F/YR23/0541/F

Land North of The Barn High Road Bunkers Hill Cambridgeshire

Erect 5 x dwellings (2-storey 5-bed) involving the formation of a new access

Officer recommendation: REFUSAL

Drawing number
1405-0700-001

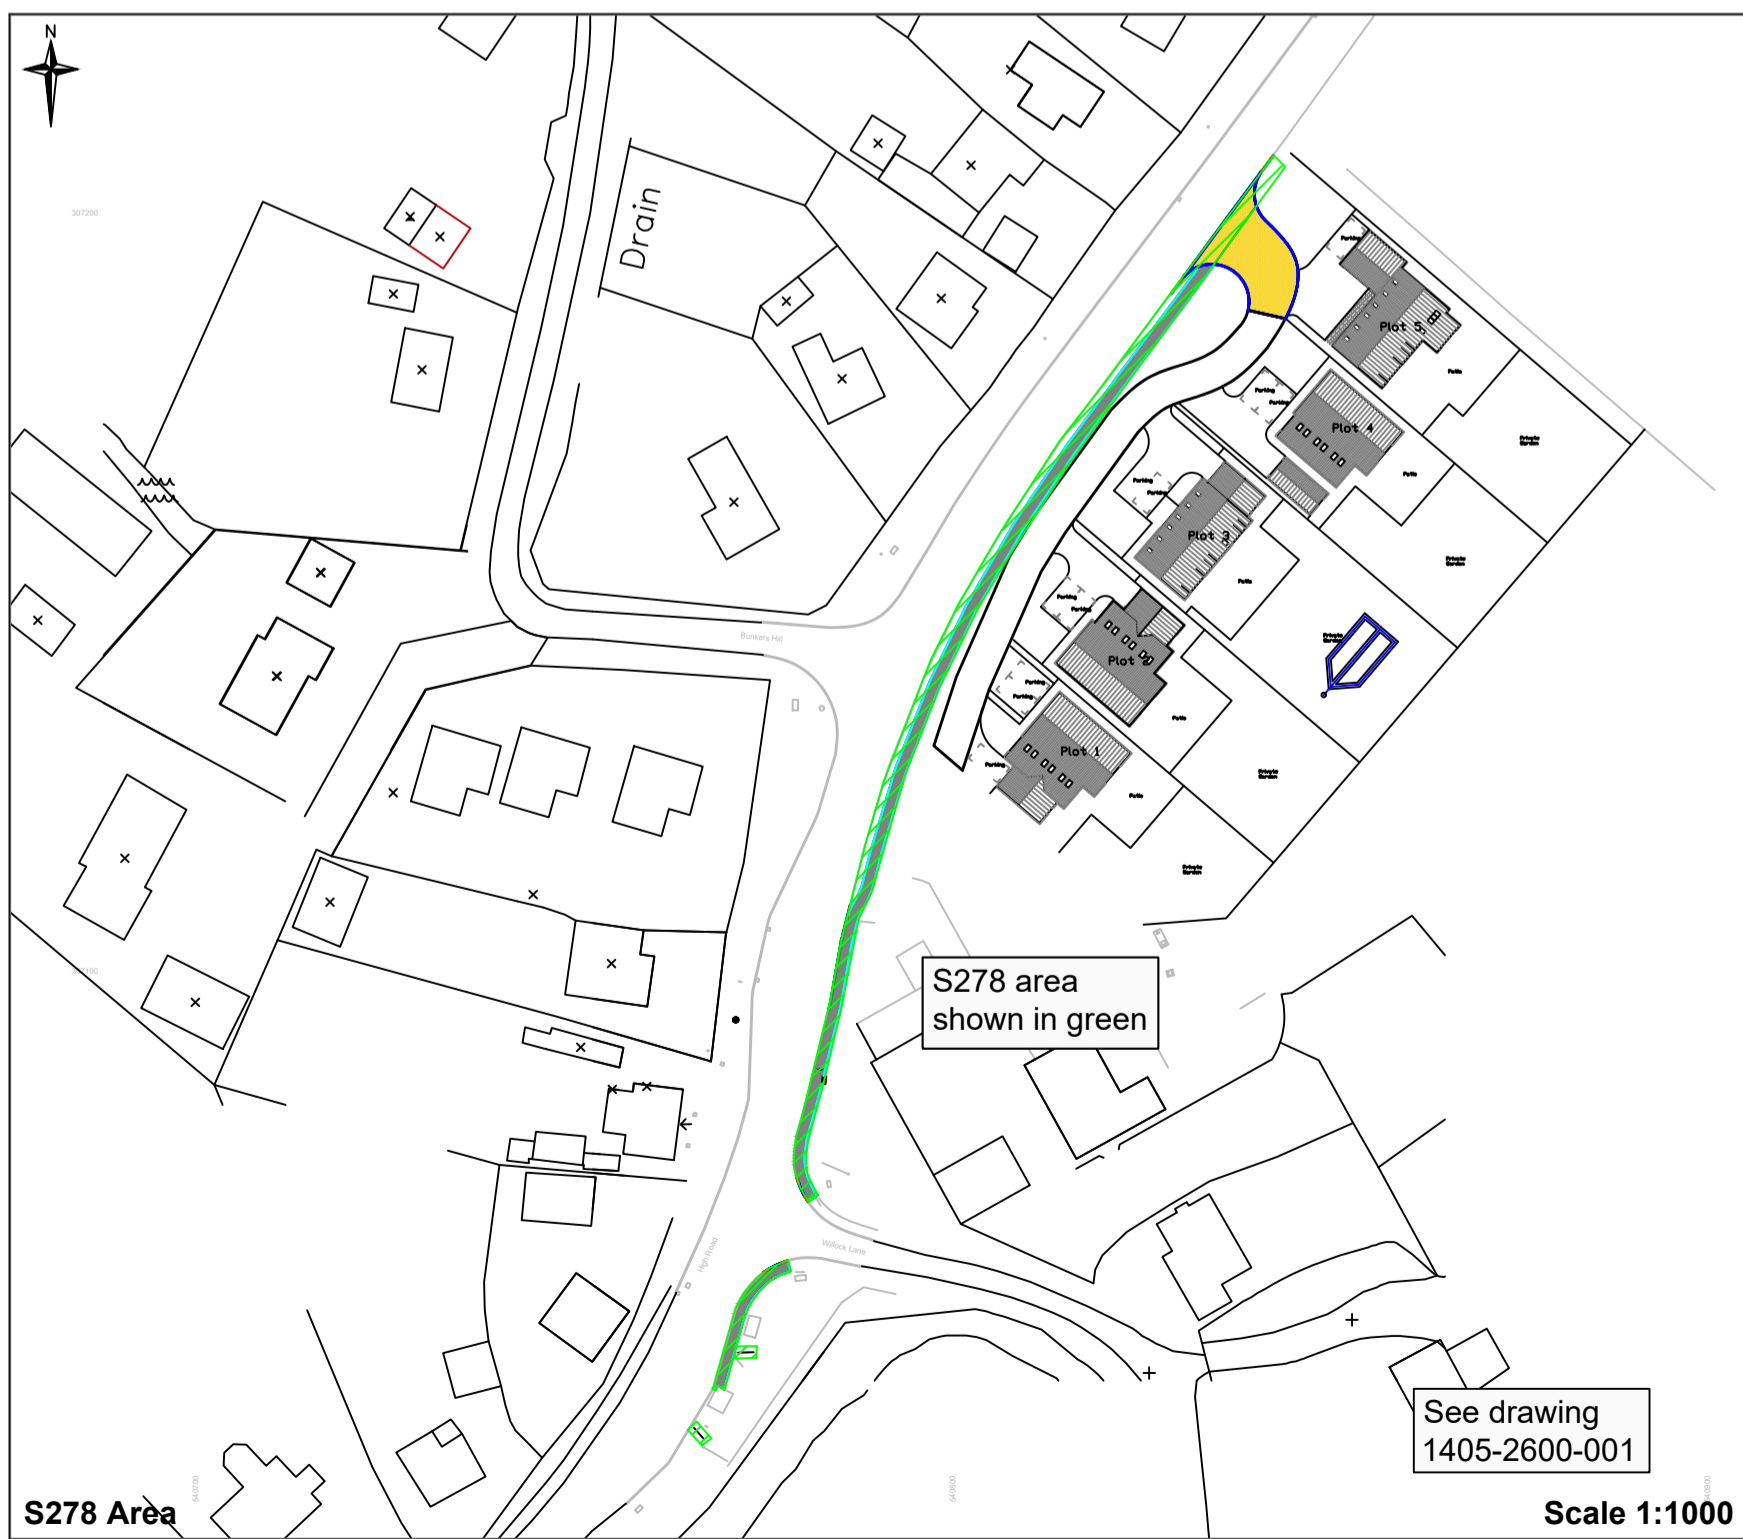
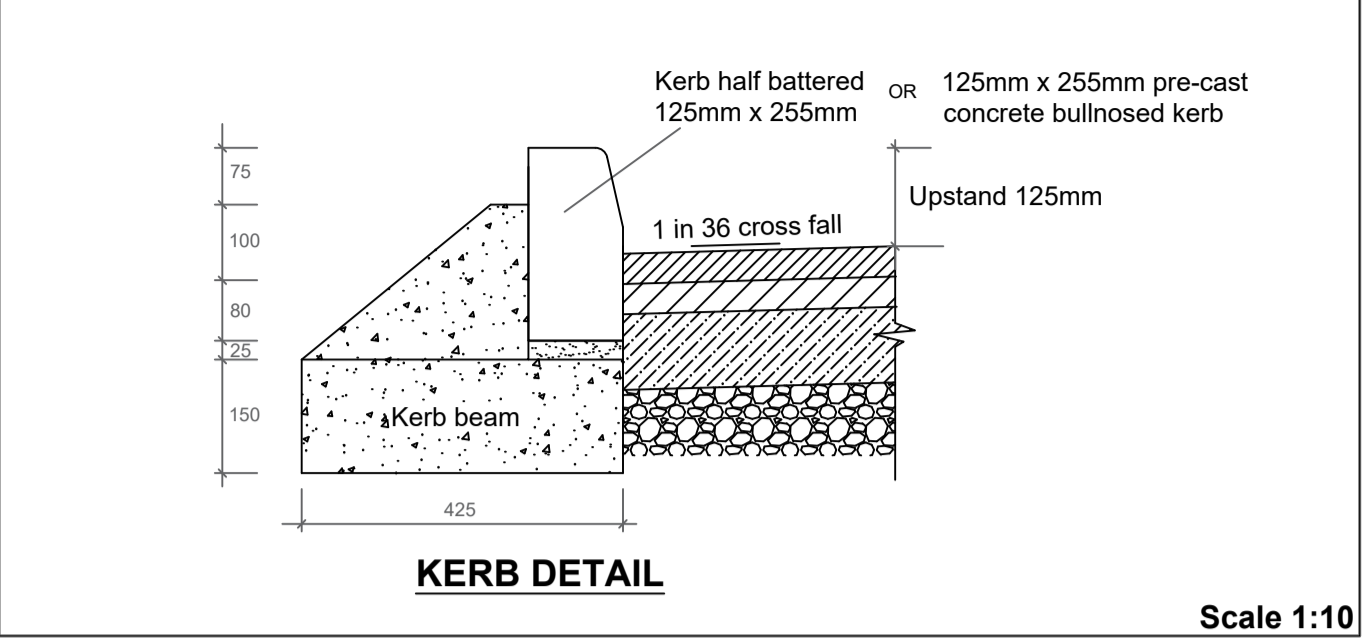
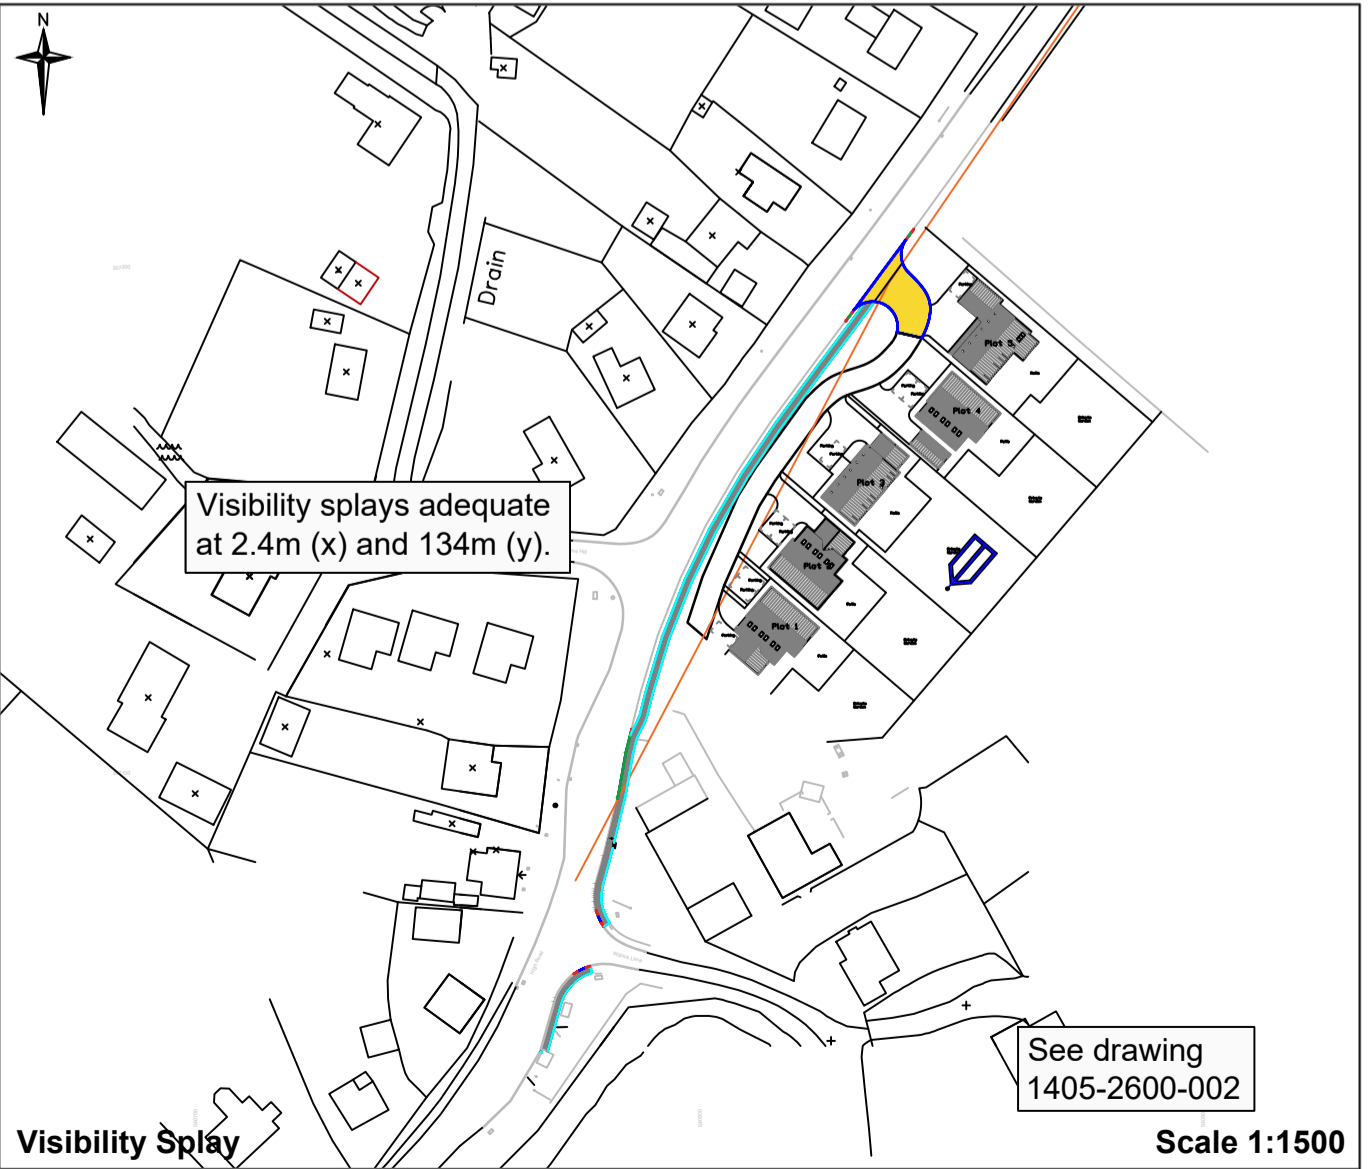
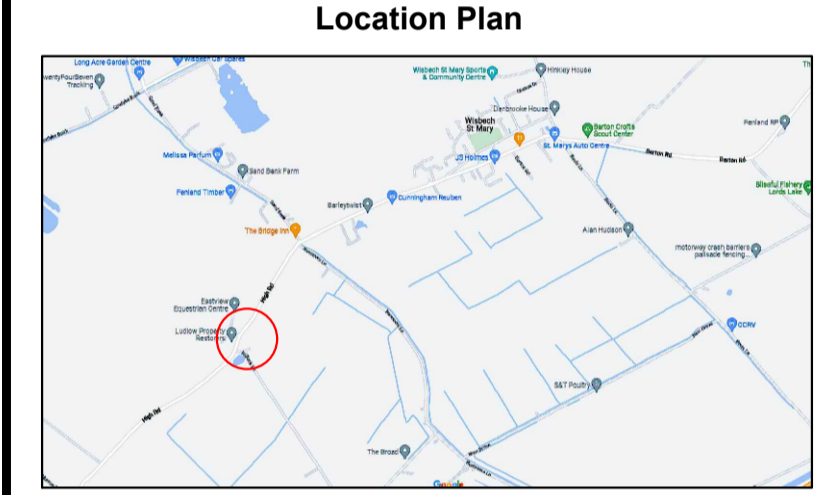
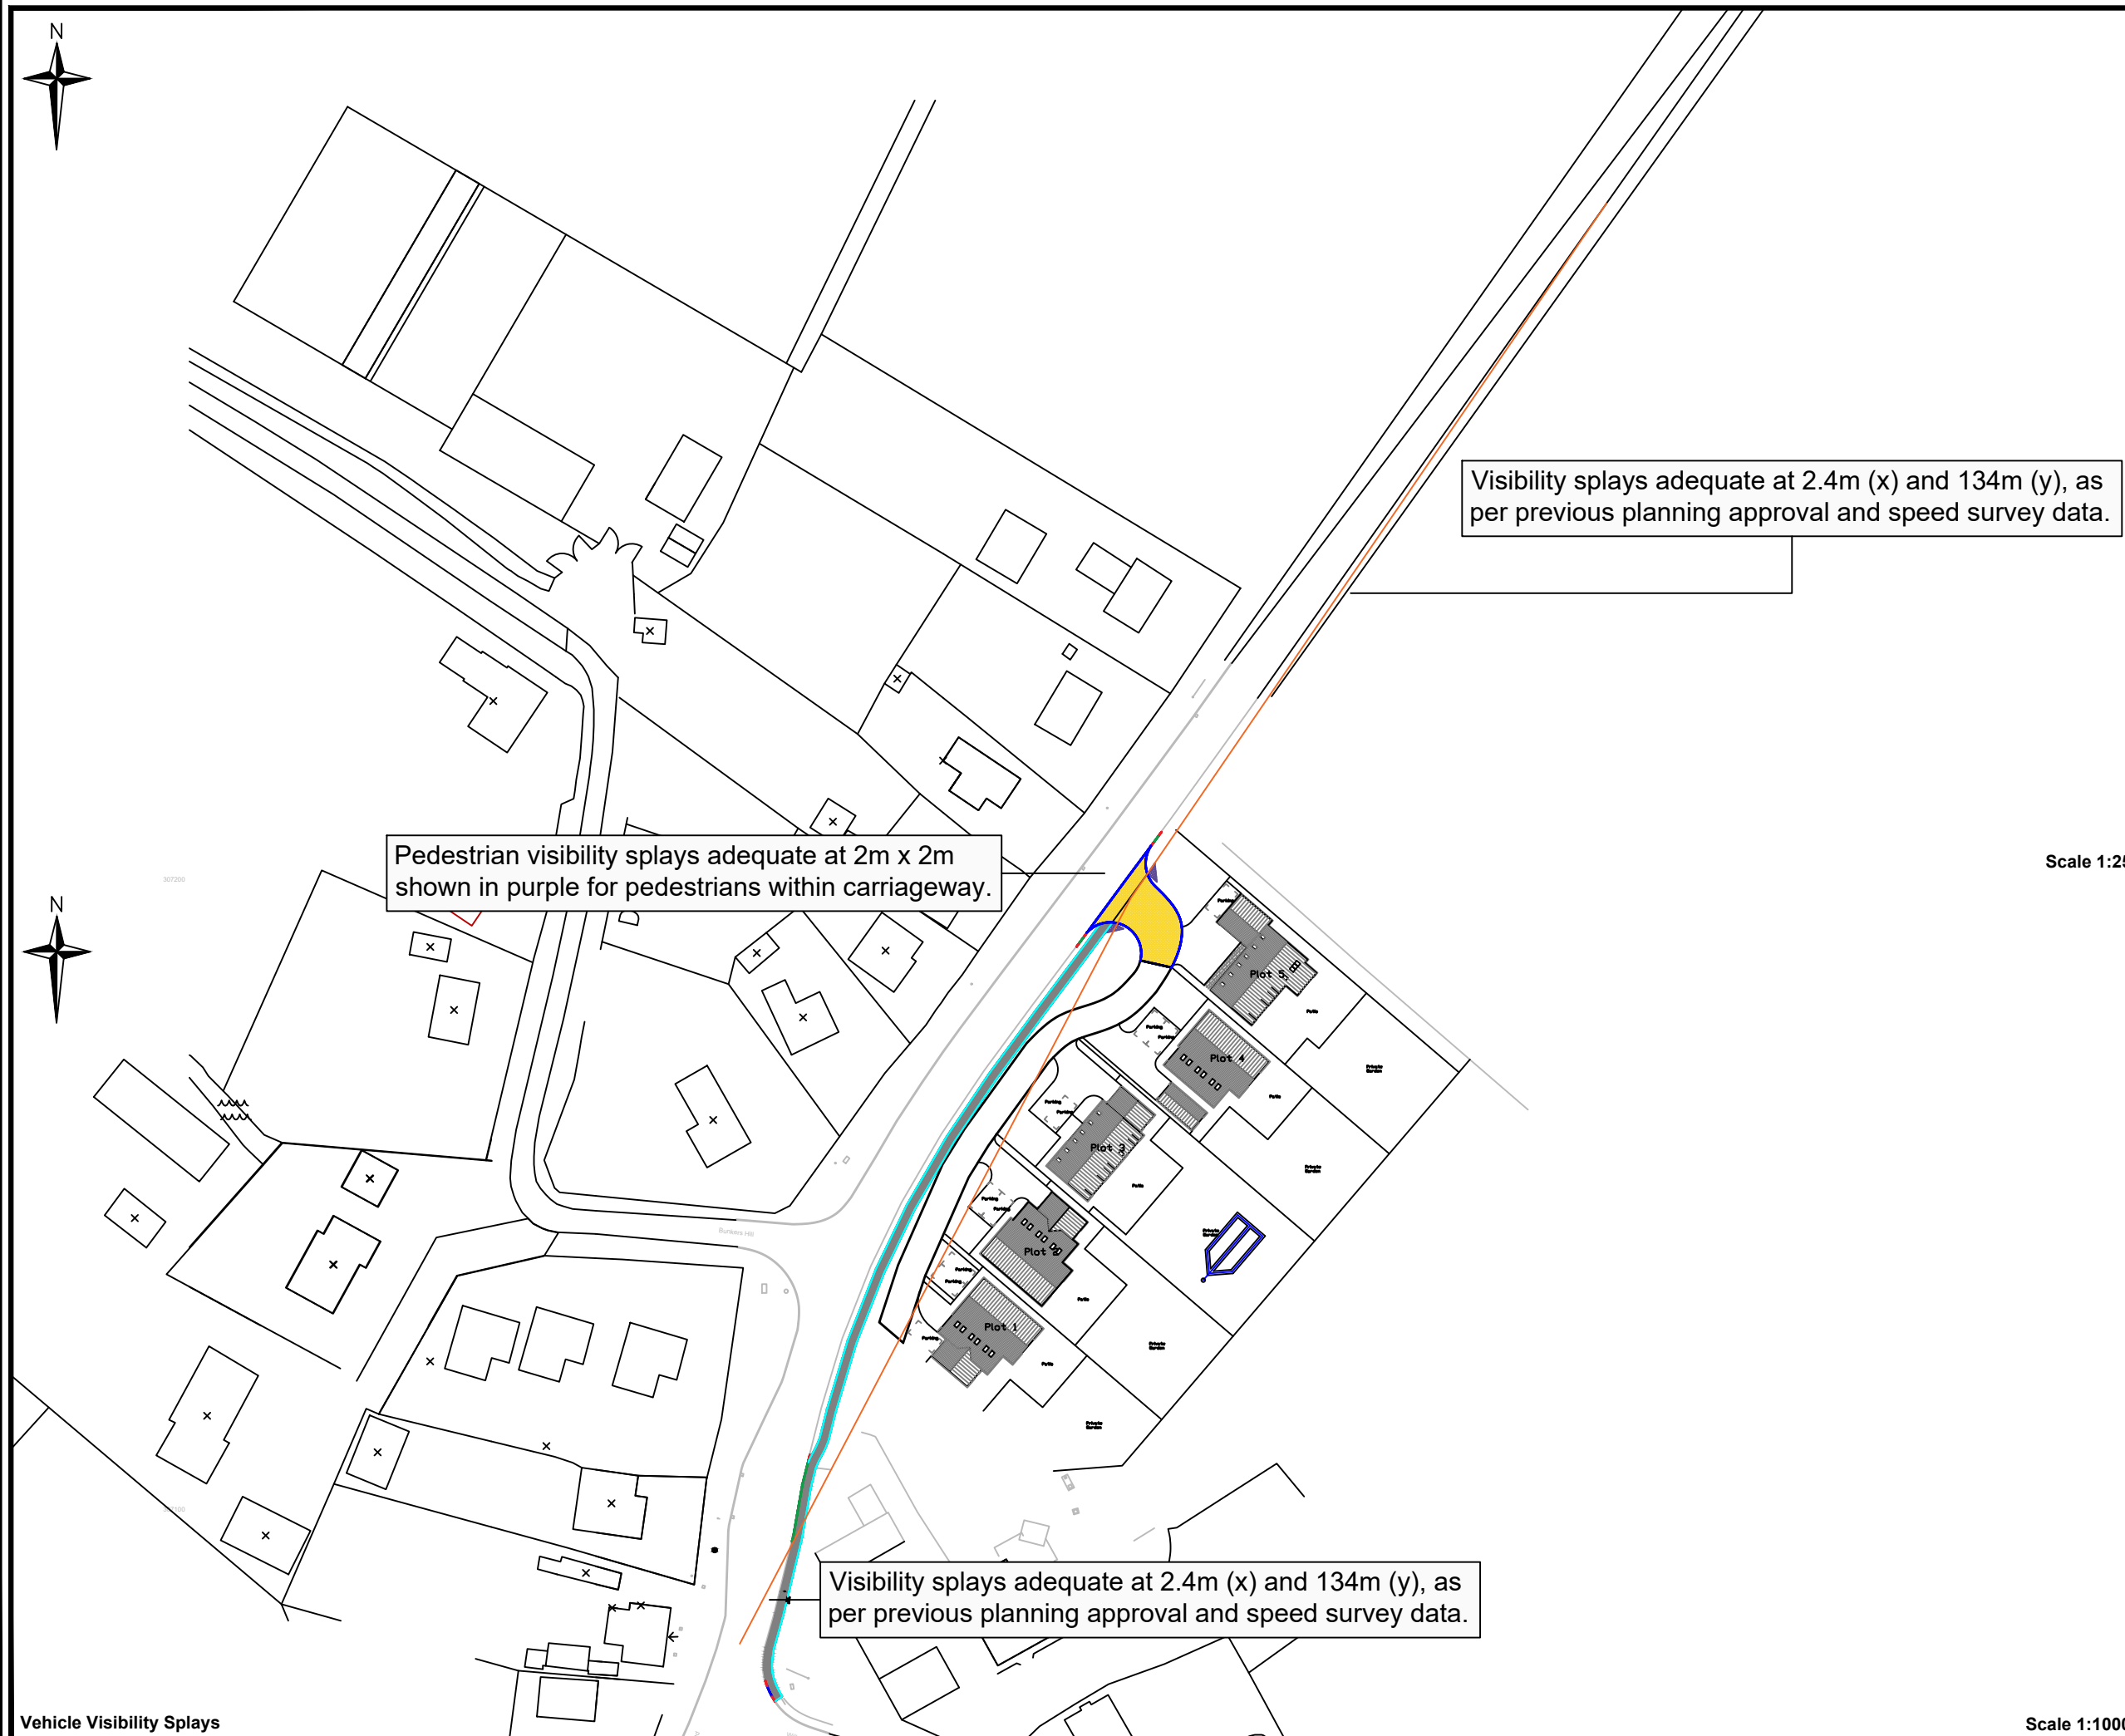
I note that the previous outline application required a 1.8m footway rather than the 1.5m shown. The current standard for footway requires a 2m wide surface, and while a narrower footway may be acceptable where physical restrictions prevent anything wider, the initial design must first look to provide widths to current standards. The applicant should be invited to amend plans accordingly. The proposed footway is shown offset by 0.9 m from the carriageway edge, presumably to allow overedge drainage from the carriageway and avoid the need of kerbing that may require installation of a positive drainage system. While I am not averse to this solution in principle, it is unclear whether the remaining verge would be sufficient to permit the necessary percolation, especially given the additional impermeable area created by the new footway.

The footway as shown appears to be located on the embankment/change in level and it is unclear how the applicant is proposing to adjust levels to accommodate construction, or what effect this will have on adjacent land. This is of particular concern were located adjacent to land not in the applicant's control and that section close to the proposed private driveway where there is a risk of a step being created.

This issue may affect feasibility of construction and the applicant should therefore be invited to provide clarification in this regard, including cross section describing how levels will be adjusted and highlighting the relative position of highway, the extent of land in their control and the effect on any third party land.

A shared private drive serving five dwellings should be served off a simple verge crossing rather than a kerbed junction. While this could be relaxed in this case given the location of the site, the detail provided on GA2 combines features of both crossing and junction on one plan. This should be rationalised to either remove the dropped kerb on the kerb line or the junction radii. Where radii are provided, these should be dimensioned and comply with the Highway Authorities requirements for s278 works. No details have been provided to indicate how private surfaces will be drained independently of the public highway.
